LIQO-E980571-00-D

**ENGINEERING CHANGE REQUEST (ECR)**

CUSTOMER DRAWING NO. D972716

DRAWING TITLE CUSTOM VENTED WASHER

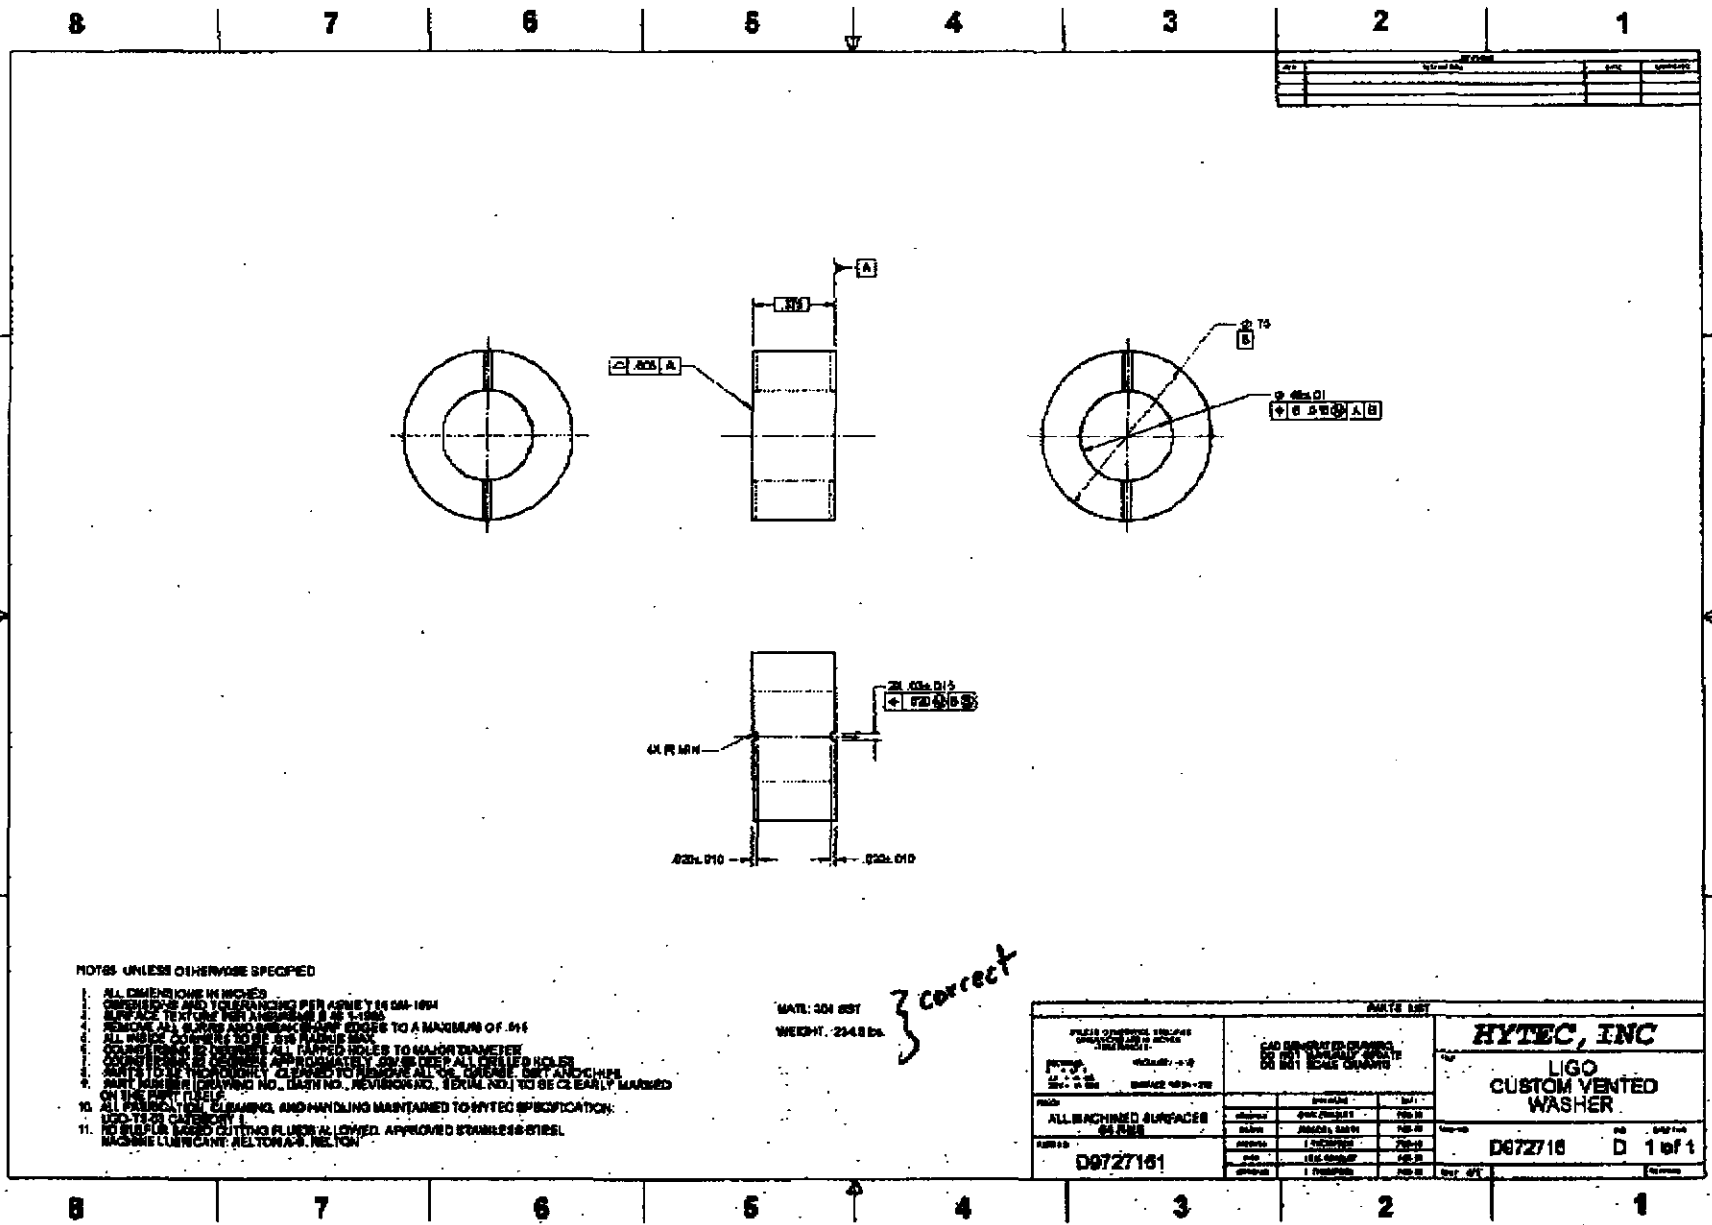
- ① CHANGE MAT'L TO 303 SST
- ② CORRECT WEIGHT
- ③ ADD NOTE 12: ALIGNMENT BETWEEN SLOTS NOT REQ.
- ④ REMOVE "4X R MSN" ⇒ CHG 1

- ① ③ REDUCE COST
- ② CORRECT DWG
- ④ CLARIFY DWG
